SUBJECT: Submits response to NRC questions on proposed mod to plant emergency electrical sys.

Subject: Oconee Nuclear Station
Docket Nos. 50-269, -270, -287
Response to NRC questions on Technical
Specification 4.6 Revision

PRE-MODIFICATION
KEOWEE/EPSSL SEQUENCE OF EVENTS FOR NON-LOAD REJECTION SCENARIO
KEOWEE UNITS NOT PREVIOUSLY ONLINE @ T=0

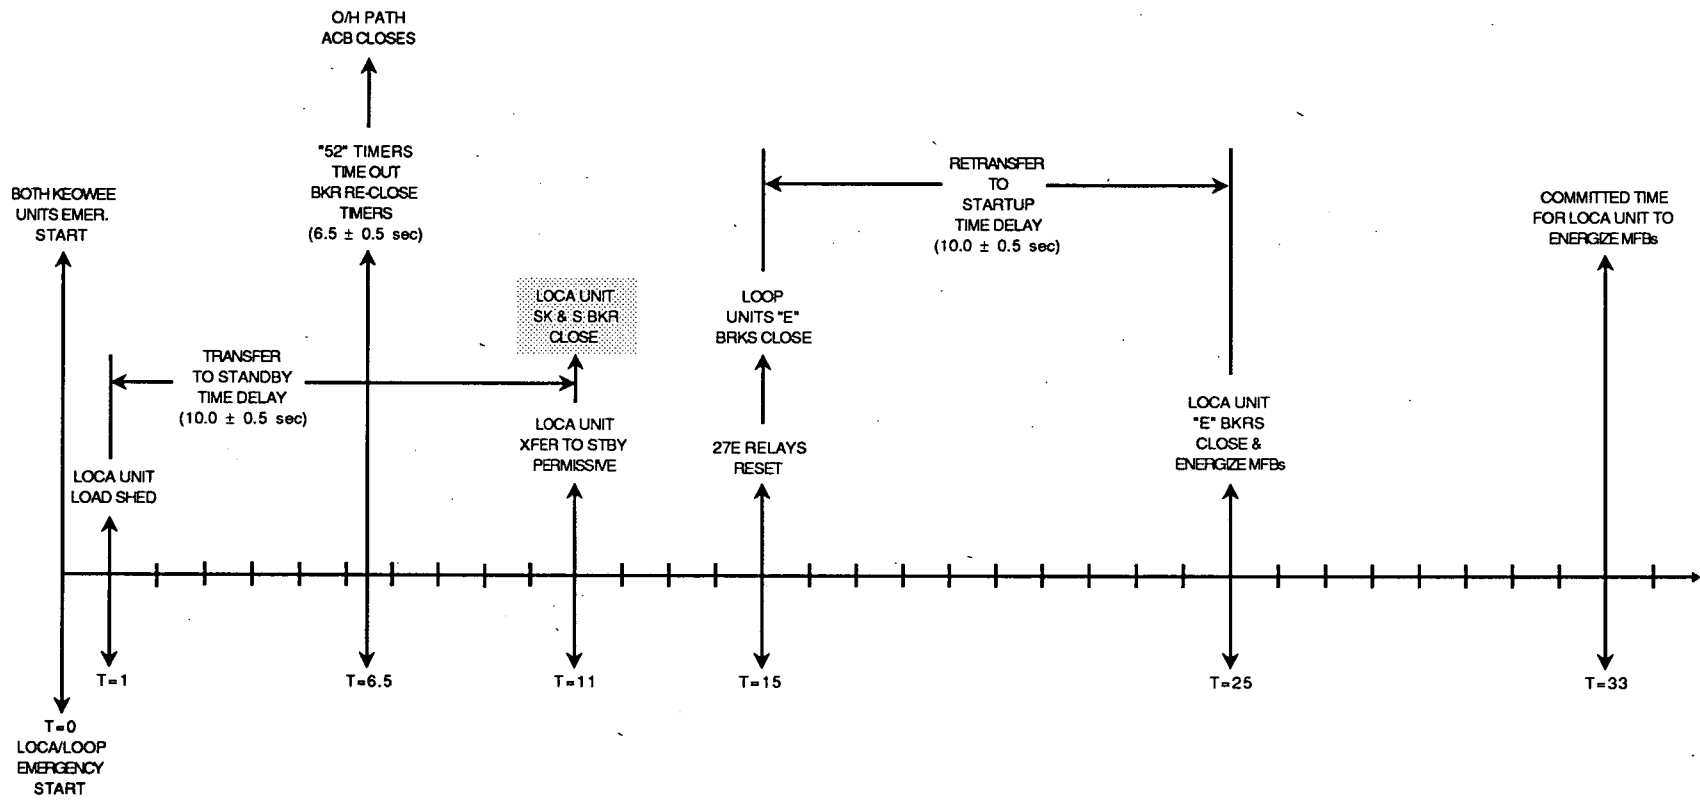
LER 93-01 references FSAR Section 15.14.3.3.6 as containing the requirements that ECCS flow be established within 48 seconds for the LOCA/LOOP scenario. Please provide a detailed discussion (using detailed timelines) of the sequence of events for worse case load rejection/overfrequency scenario which includes the worst case values (considering uncertainties) for undervoltage relay reset, frequency relay setpoints (pickup and reset) and associated time delays, breaker closure times, retransfer startup time delays, etc. Compare this to the worst case sequence for a non-overfrequency scenario to provide the basis for margin between the current FSAR analyses and a worse case load rejection scenario. Discuss any modifications and/or administrative controls that have been or will be implemented that ensure the analysis of FSAR Section 15.14.3.3.6 remains bounding.

The 48 second requirement that is listed in FSAR Section 15.14.3.3.6 can be described in two separate steps. The first part is the Keowee/EPSP time and the second part is the MOV stroke time. FSAR Section 6 describes the MOV stroke time as being 15 seconds. This 15 second allowance also bounds the start times for the Engineered Safeguards pumps. Thus, the Keowee/EPSP function must be performed within 33 seconds. Attachments 4-1, 4-2, 4-3 and 4-4 show the timelines for non-load rejection and load rejection scenarios. Tolerances are included in these figures to quantify the worst case response time. Also, these timelines indicate the pre-modification and post modification configurations.

As evident by the timelines, following the installation of the proposed modification, Keowee will be in compliance with its design basis.
